DEVELOPMENT REVIEW BOARD SUPPLEMENTAL SUBMITTAL

PROJECT NO. 1004000/ PR-2018-0001
Application No. SI-2018-00031

SUBMITTAL DESCRIPTION: Updated Plan Set with comments

**RE: PRIMROSE DRB PROJECT NUMBER: 2018-001183 (1004000)
SITE DEVELOPMENT PLAN FOR BUILDING PERMIT**

PRIMROSE SCHOOL OF NW ALBUQUERQUE
SITE PLAN FOR BUILDING PERMIT

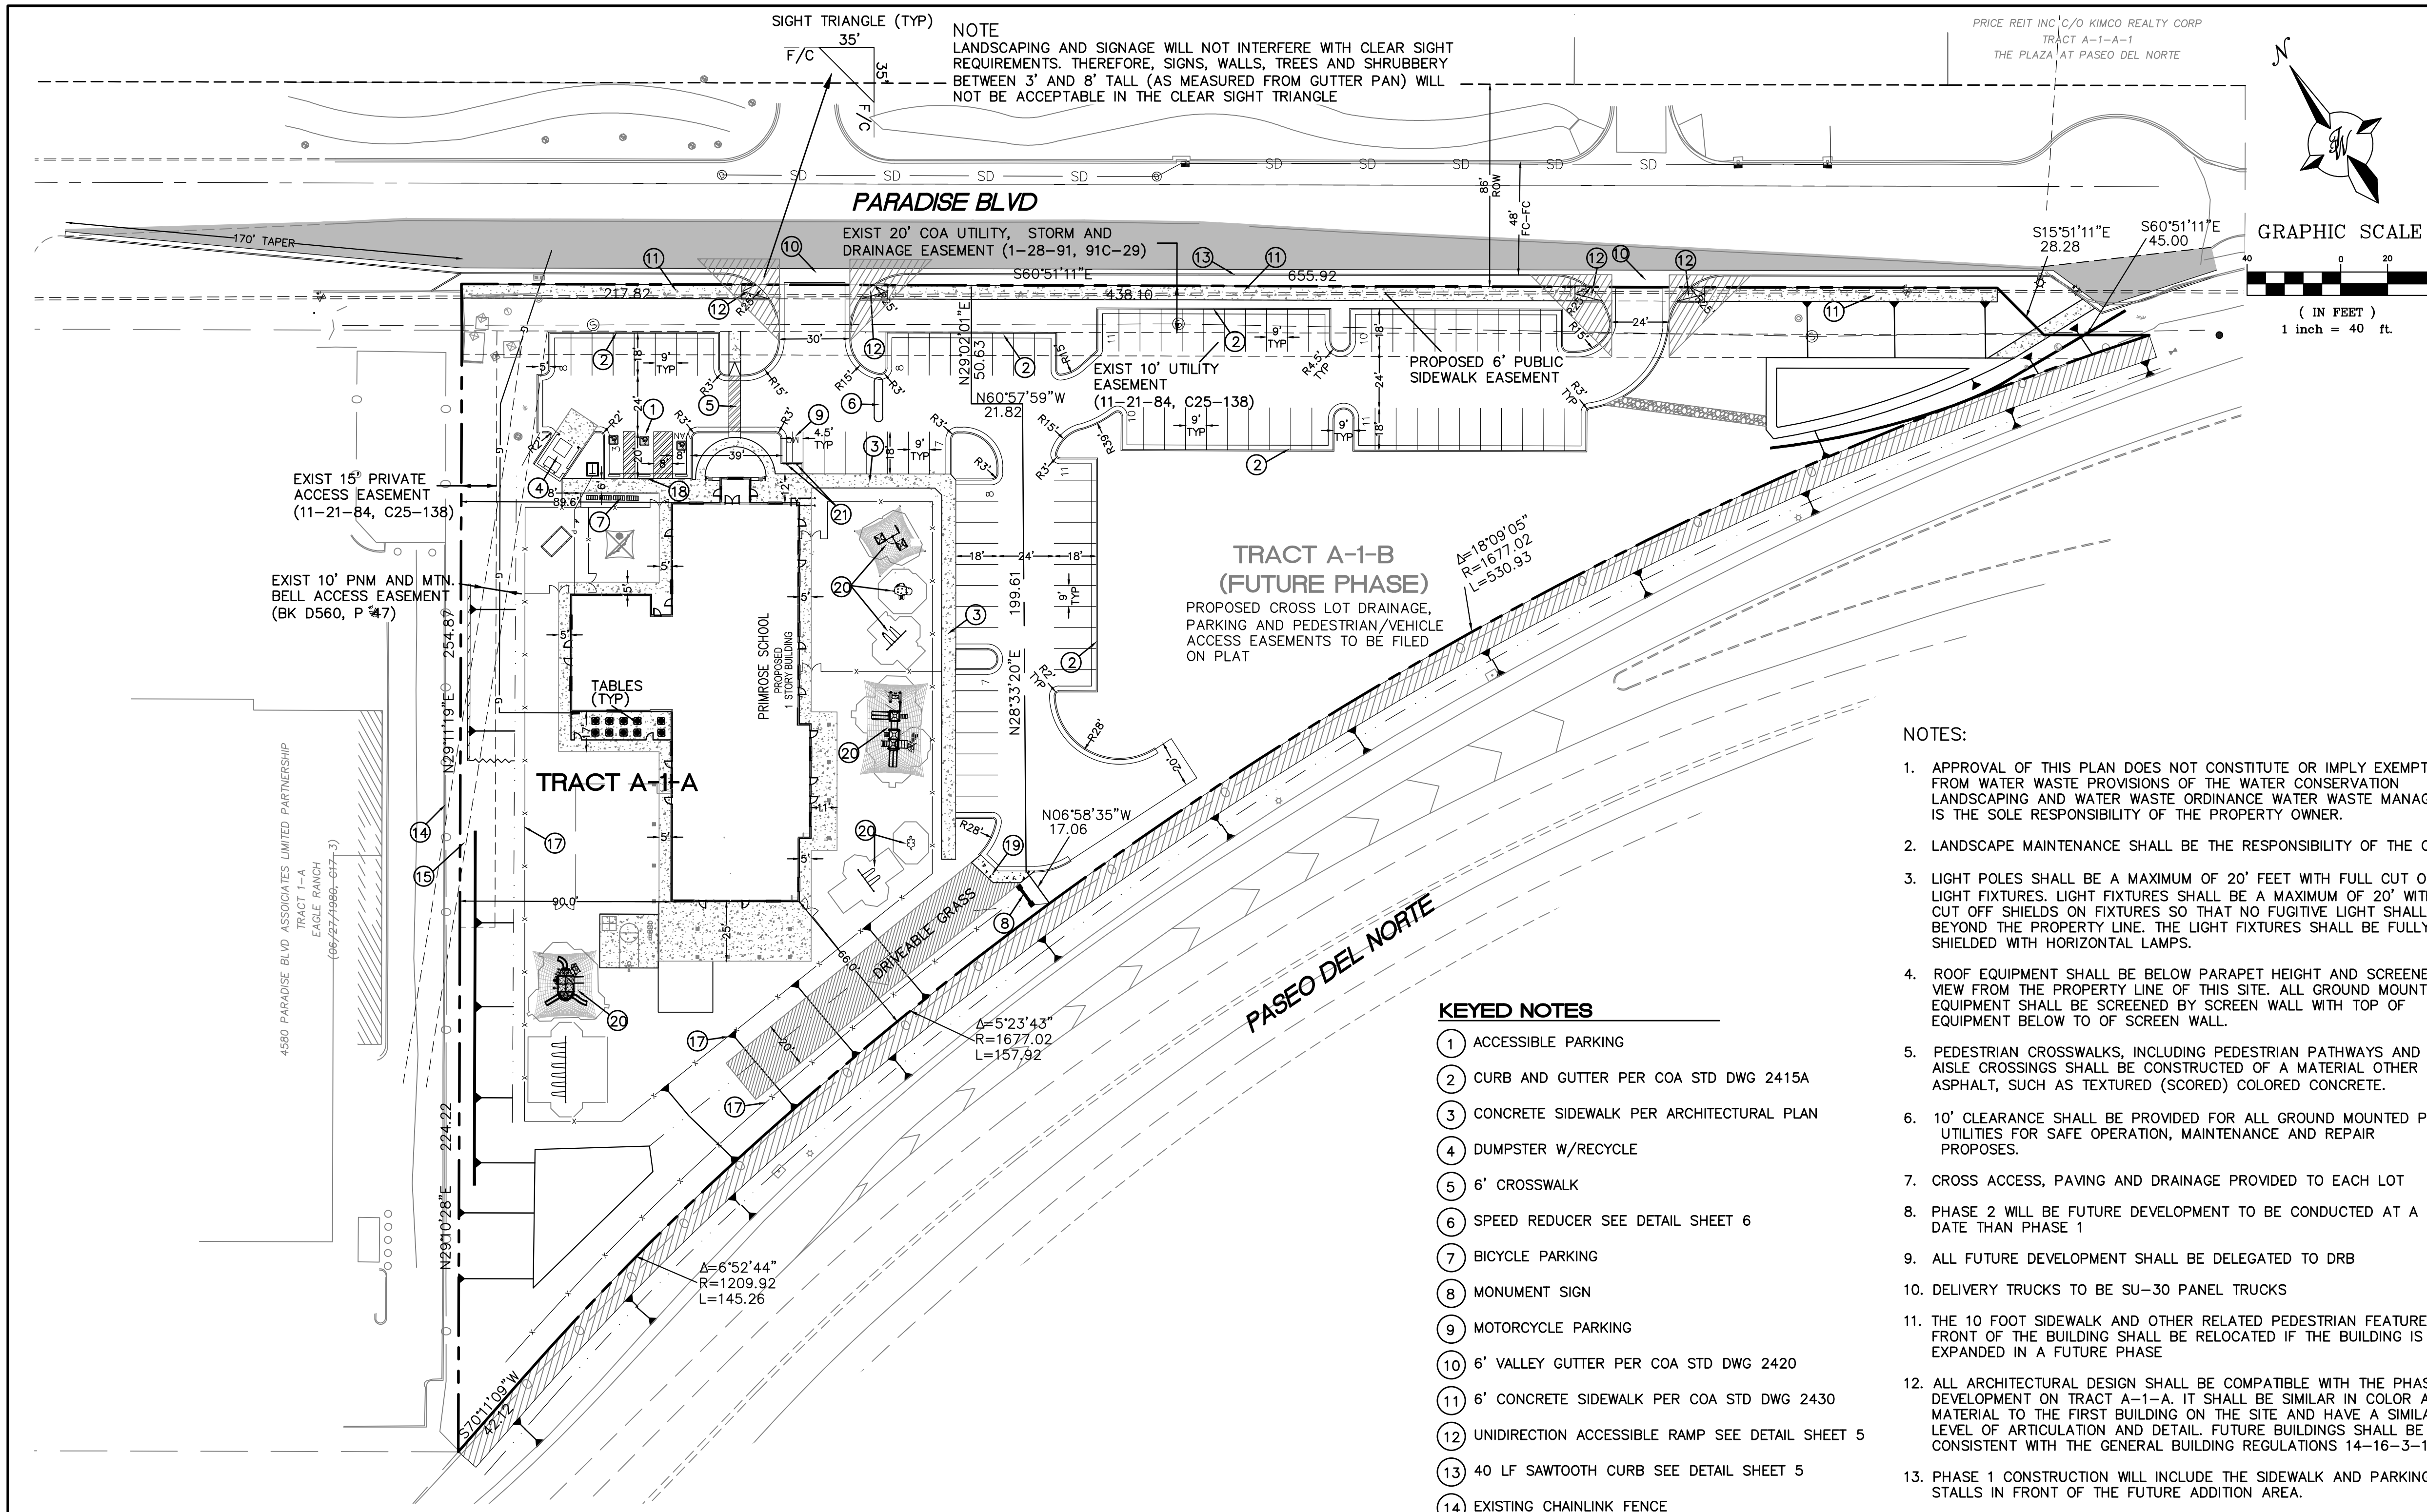
1. Remove ramp at NW corner of the site and place sidewalk at property line.
The ramp was removed.
2. Provide sidewalk width on site around playground.
Dimensions were added to all of the sidewalks around the playground.

5. Right of way dedication is required.
We are unsure why a right of way dedication is required. The current right of way width is 86 feet and the street ends at a cul de sac. The sidewalk was moved to the back of the right of way line and a public pedestrian easement will be recorded at the time of platting.

6. A cross lot access easement is required.
A cross lot access easement is noted on Sheet 1 and will be provided on the plat.

PRIMROSE SCHOOL OF NW ALBUQUERQUE	DRAWN BY pm
	CONCEPTUAL GRADING PLAN	DATE 6-27-18
	TIERRA WEST, LLC 5571 MIDWAY PARK BL NE ALBUQUERQUE, NEW MEXICO 87109 (505) 858-3100 www.tierrawestllc.com	DRAWING
RONALD R. BOHANNAN P.E. #7868	SHEET # 3	JOB # 2017092

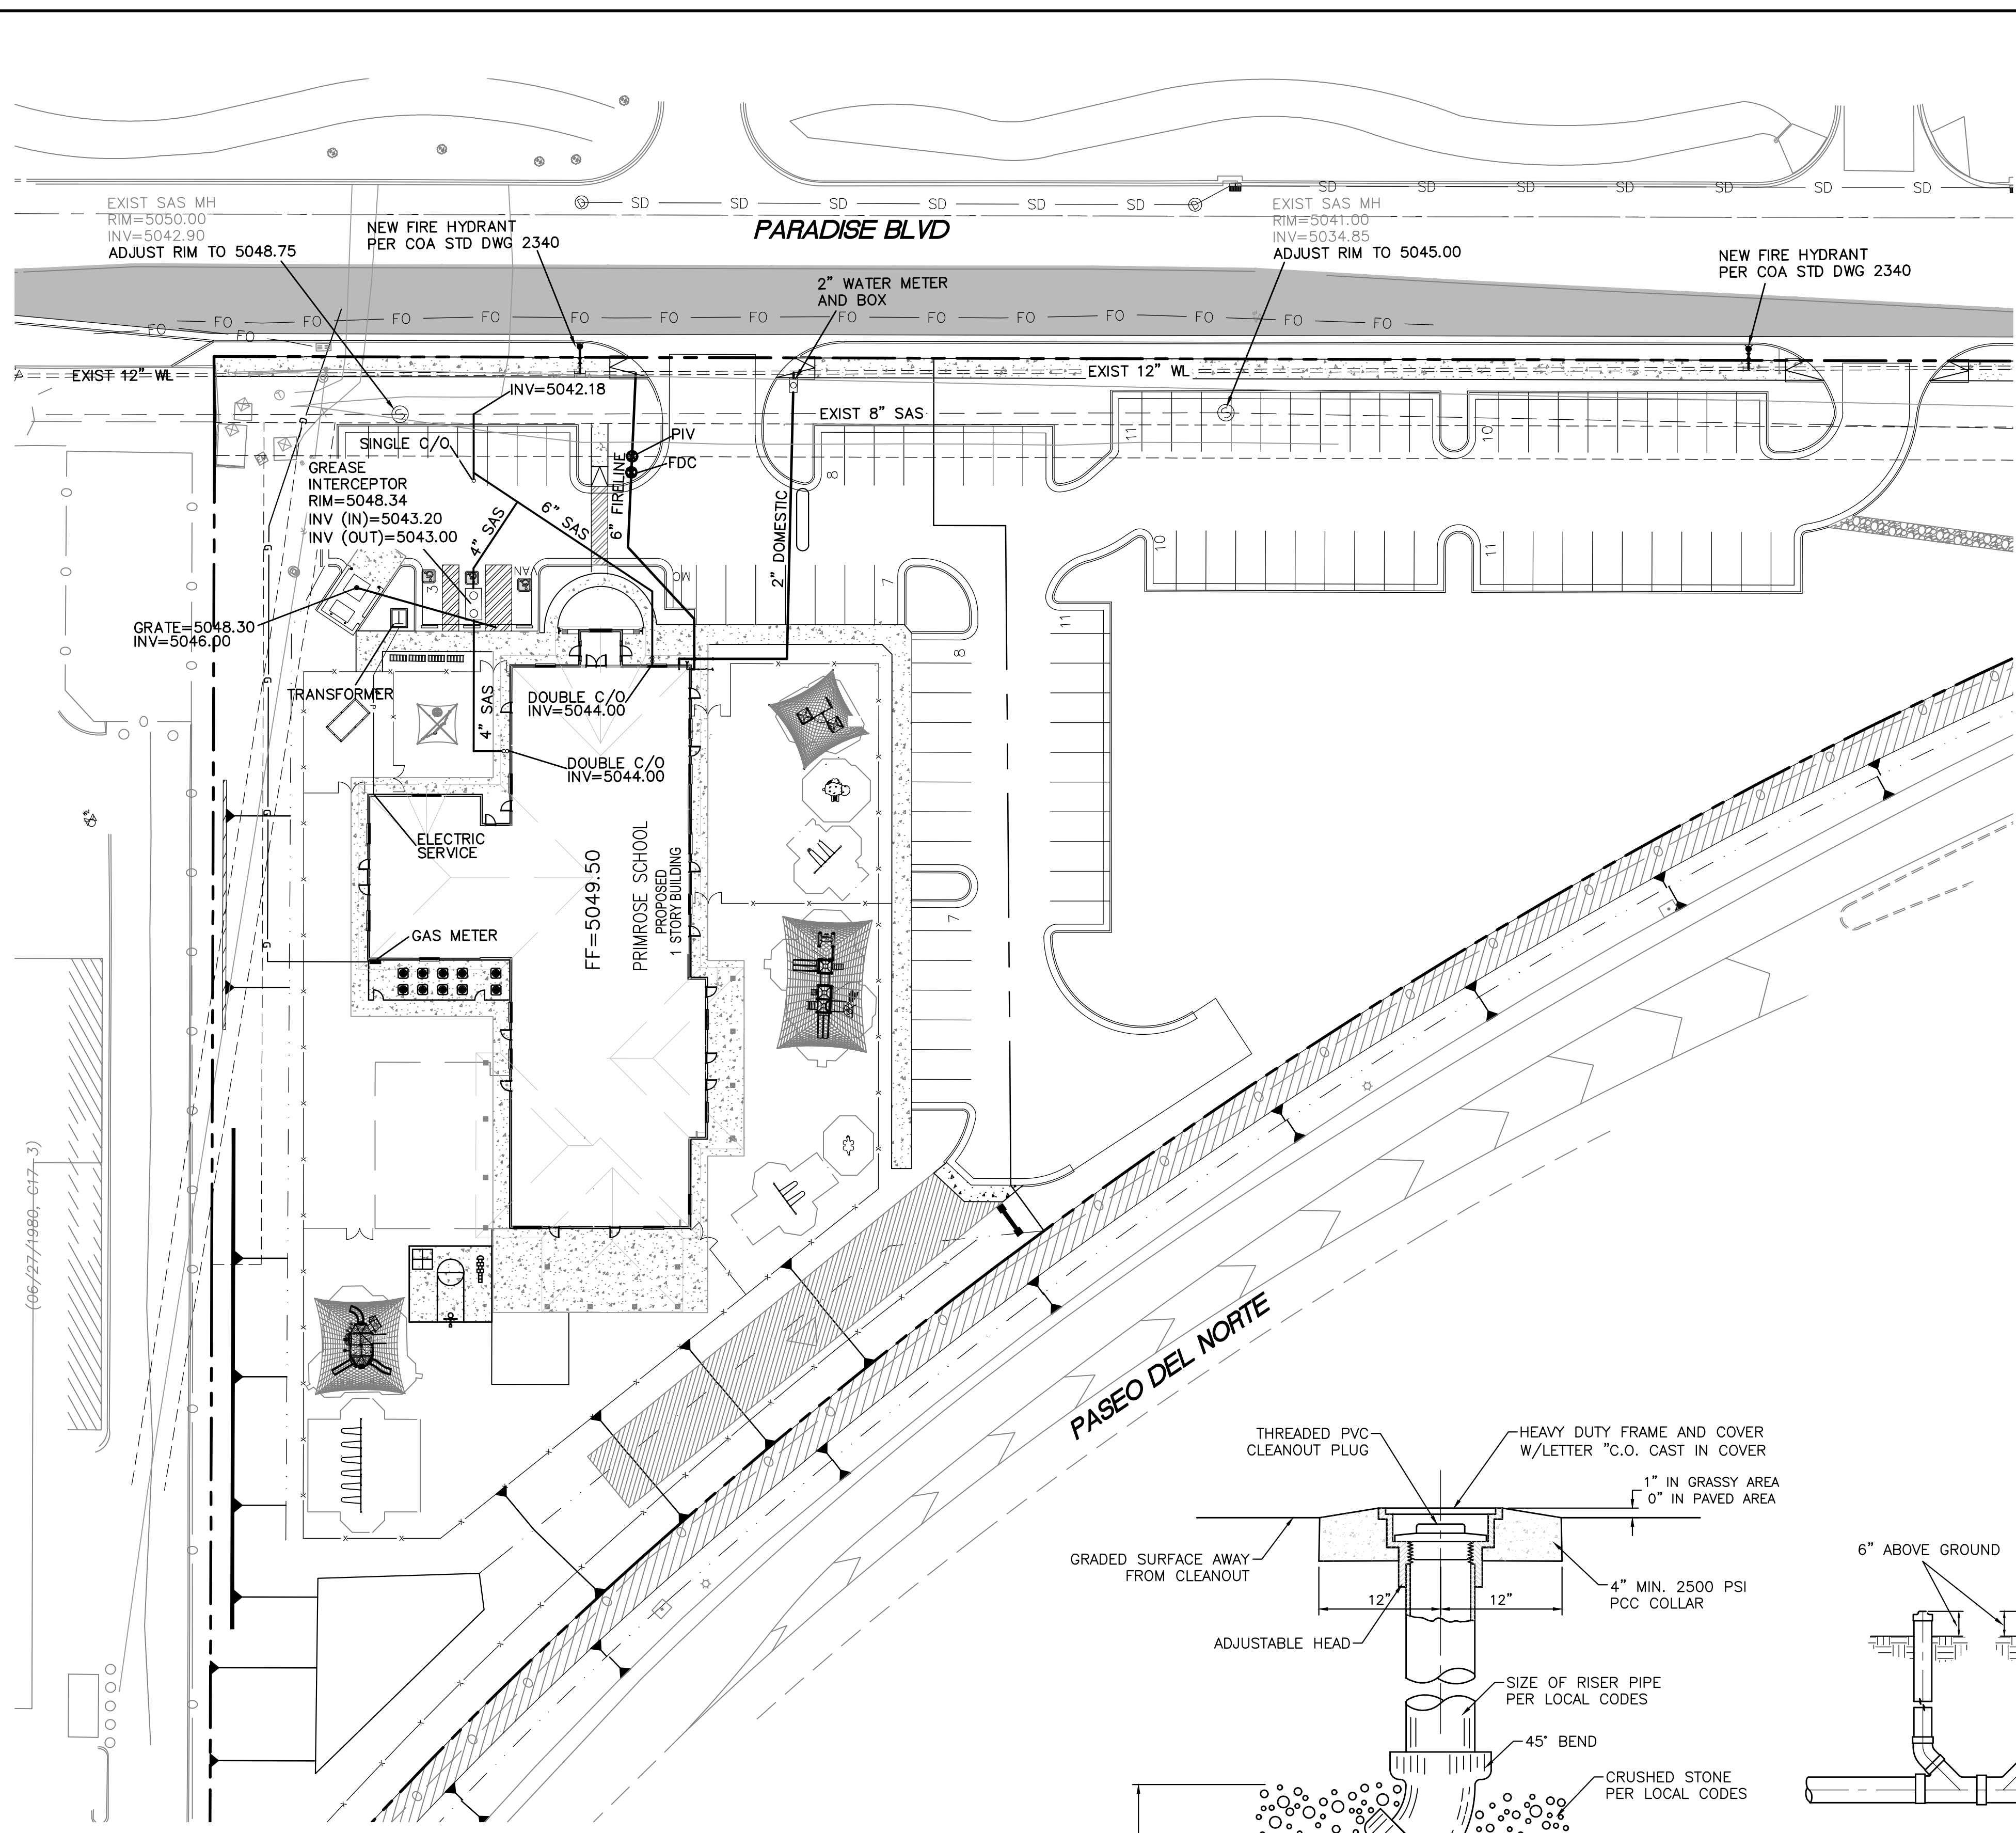
1. Revisions are still required to the Grading and Drainage Plan.
A revised Conceptual Grading Plan and Drainage Report was submitted to Hydrology on June 26th.
2. Hydrology recommends that any necessary revisions to the previously approved Infrastructure List be made prior to Work Order.
Base on the revised Grading Plan and Drainage Report there are no public drainage facilities required for this project.
